Documentation of Public Meeting

US 79

CSJ: 0204-01-063

US 79 (I-35 to east of FM 1460)

US 79 and Mays St. Intersection

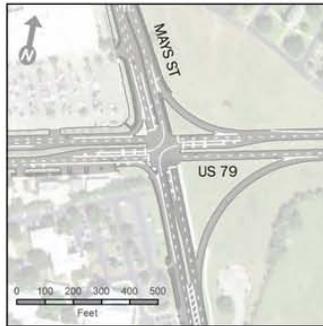
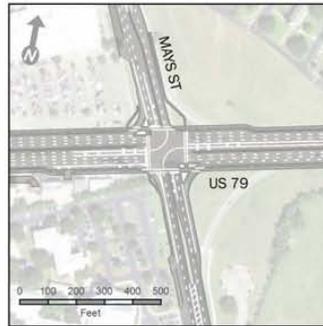
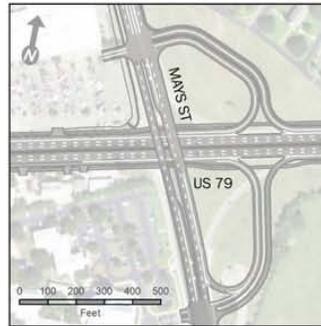
2	(blank)	(blank)	9/28/2017	Comment Form	Keep the large sweeping right turns at 79 and the IH-35 northbound frontage road. Please don't make traffic come to a stop at this intersection. Prefer the overpass option at Mays to at-grade.	Thank you for your comment. The alternative where a stop condition was shown did not include a dedicated lane for the turning traffic to enter into. In that situation, the current district policy is to bring the traffic to a stop because it is more clear to the turning traffic that this is a yield condition, the vehicles are more likely to yield to pedestrians, and the drivers can more easily see oncoming traffic since it is approaching from the side and not from behind. If this alternative is chosen, we would continue to analyze the traffic model to determine the optimal lane configuration for this intersection. If it is determined that a dedicated lane for the turning traffic to enter into is warranted, then the design would be updated to include the sweeping right turn. If the optimal lane configuration does not include a dedicated lane for the turning traffic to enter into, the configuration would remain as shown for the purposes of safety as explained.

#	Last Name	First Name	Date Received	Source	Comment (Verbatim)	Response
					<p>use path on the north side be built and illuminated before the rest of the construction? This will prevent pedestrians from having to walk through construction work or in traffic. If this is not possible, what is the plan for pedestrian safety during the construction? Again, please do not allow equipment or materials storage to displace pedestrians into traffic.</p> <p>3. Retraining the jaywalkers who cross 79 between the apartments and the grocery store. The existing intersection at AW Grimes is the most pedestrian-friendly one anywhere along Hwy 79 so it is frustrating to see families laden with packages and small children braving traffic to the west. I think part of the reason this happens is that the apartment fence does not have a gate at its northeast corner. I understand the final buildout will require all pedestrians to cross at the Grimes intersection. Please figure out a safe pedestrian crossing for people to use during the construction itself.</p> <p>4. Please design the new lighting to illuminate the sidewalks as well as the roadway if the sidewalks will not have their own illumination. The lighting along Grimes between Hwy 79 and Seton Hospital is a pretty good example. The lighting along Mays north of 79 is a pretty bad example.</p> <p>5. The new plan includes a double left turn lane onto northbound Sunrise and onto southbound Georgetown. Sunrise has two northbound lanes and no residential driveways. Georgetown has just one southbound lane and many residential driveways. Please reconsider this double left lane for the sake of people who live along Georgetown and their need to back out of their driveways. The 30 mph speed limit is posted but not observed. If it is the 2040 traffic forecast directing this decision then can't the 2nd left turn lane be delayed until 2039?</p> <p>6. One of the two alternatives for the Mays intersection would displace a historic marker, a</p>

#	Last Name	First Name	Date Received	Source	Comment (Verbatim)	Response
					<p>fantastic monument tree, and a small parking lot police use. Please choose the other alternative.</p> <p>I appreciate your efforts to communicate with the neighbors and to mitigate the inconveniences associated with the construction.</p> <p>Thank you, Cathey Carter</p>	
4	Carter	Cathey	10/9/2017	Email	<p>Hello TxDOT, Please revise the plan to provide an entrance to HEB from 79 east-bound. Making downtown residents go through the Grimes/79 intersection and then enter the parking lot from north-bound Grimes will be time-consuming and obnoxious.</p>	<p>Thank you for your comment. Access to the HEB for eastbound traffic would be provided via the U-turn at AW Grimes. We believe this would be safer than the current scenario, and, in our coordination with representatives from HEB, they are in agreement that this configuration would be better for eastbound traffic.</p>
